Approved Septic System Plan Howard County Health Department

CLARK • FINEFROCK & SACKETT, INC.
ENGINEERS • PLANNERS • SURVEYORS

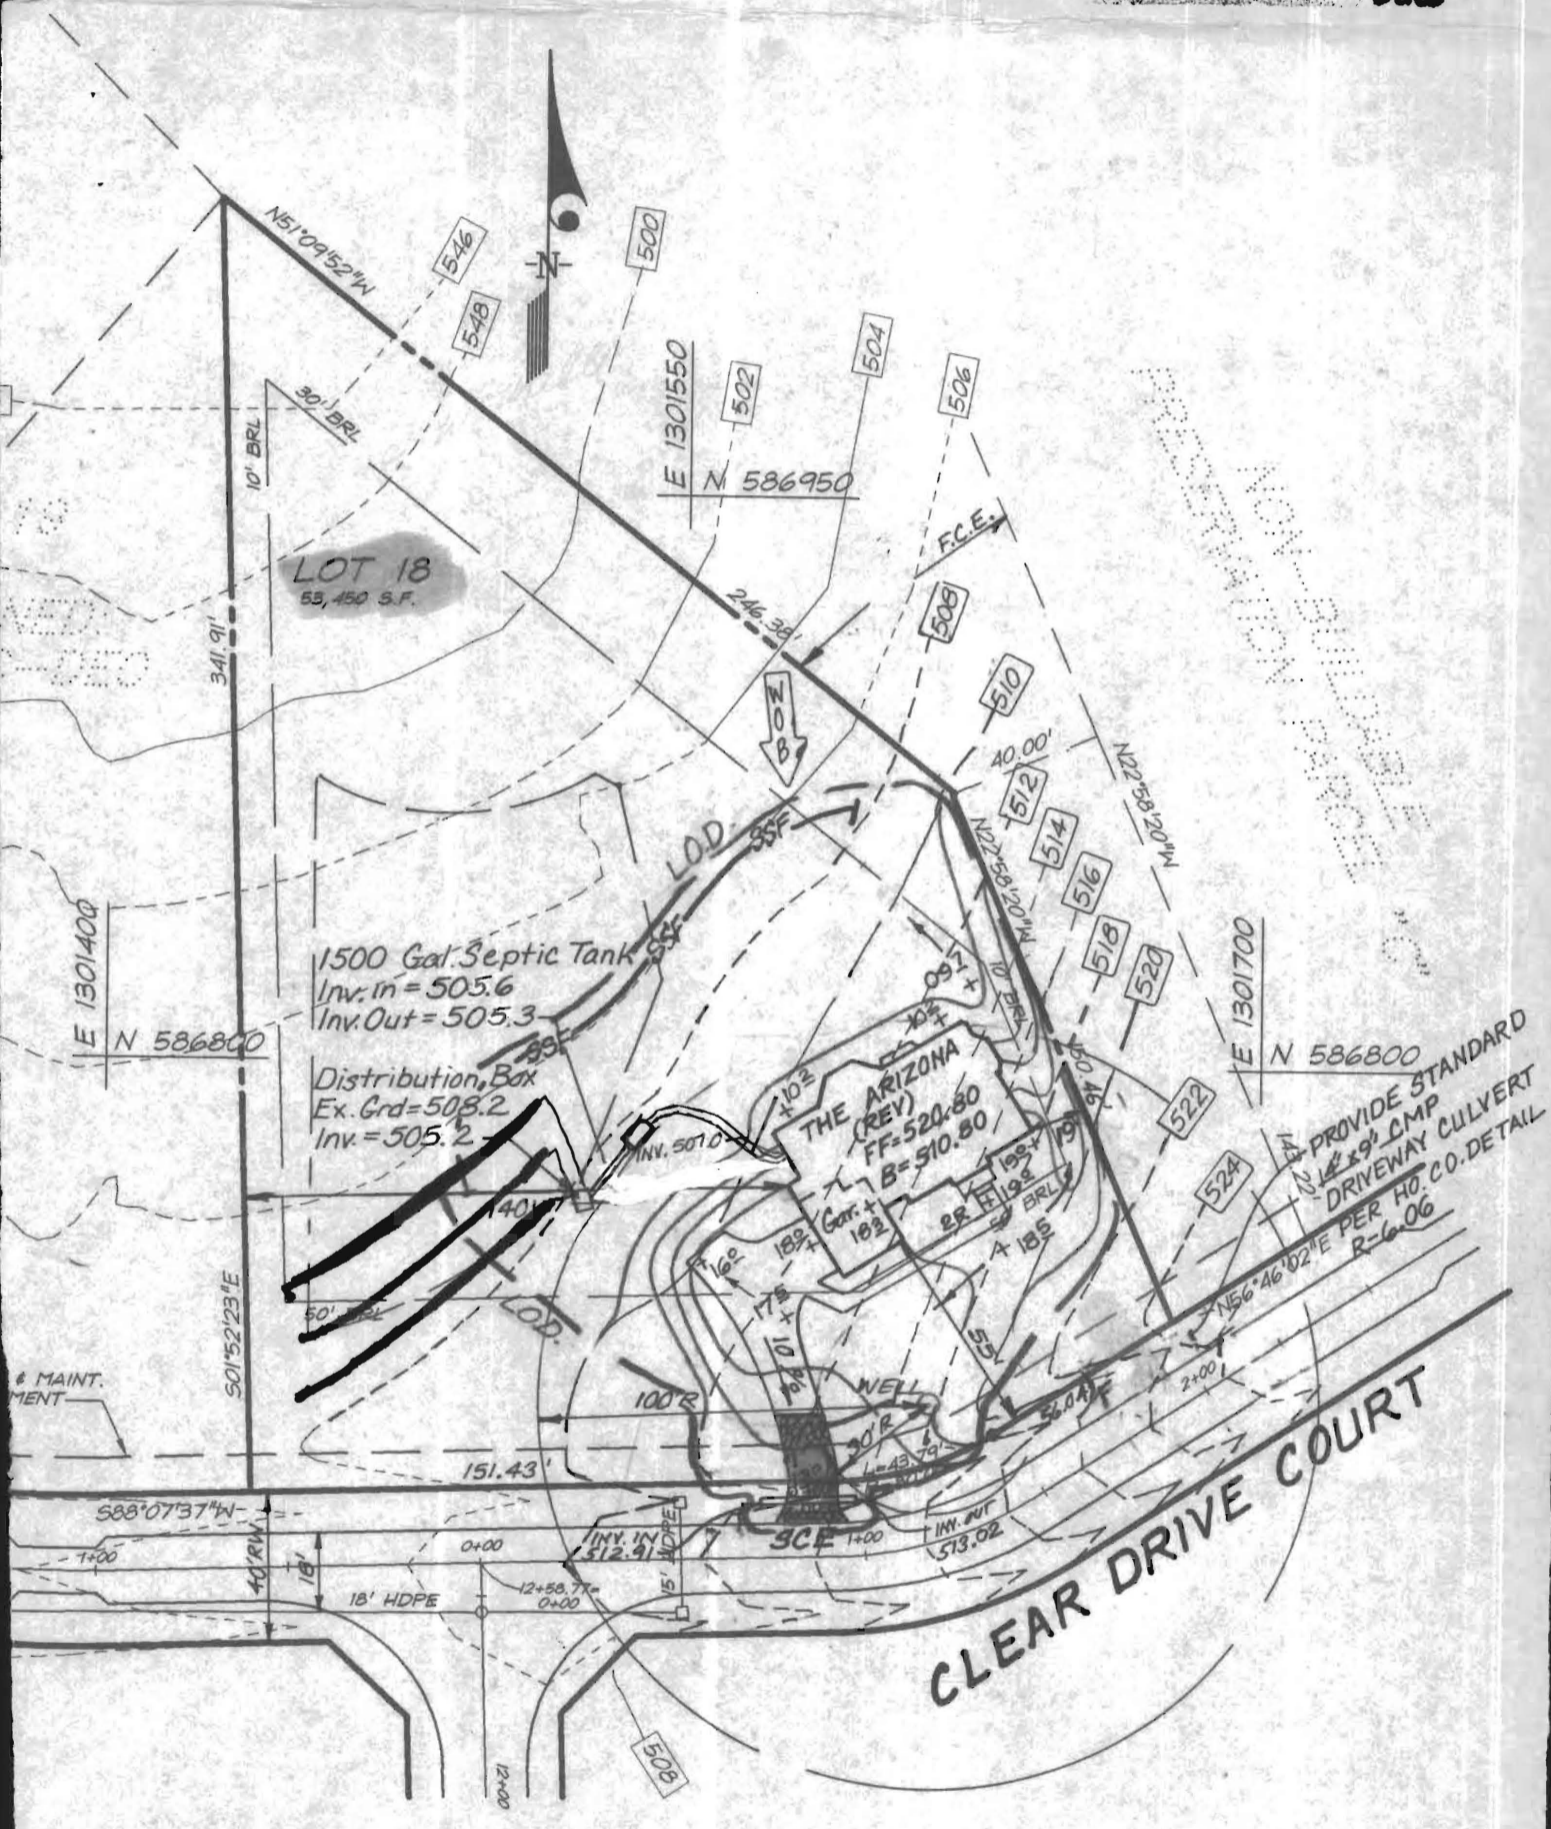
Total linear feet of trench 240
required ~~280~~ feet
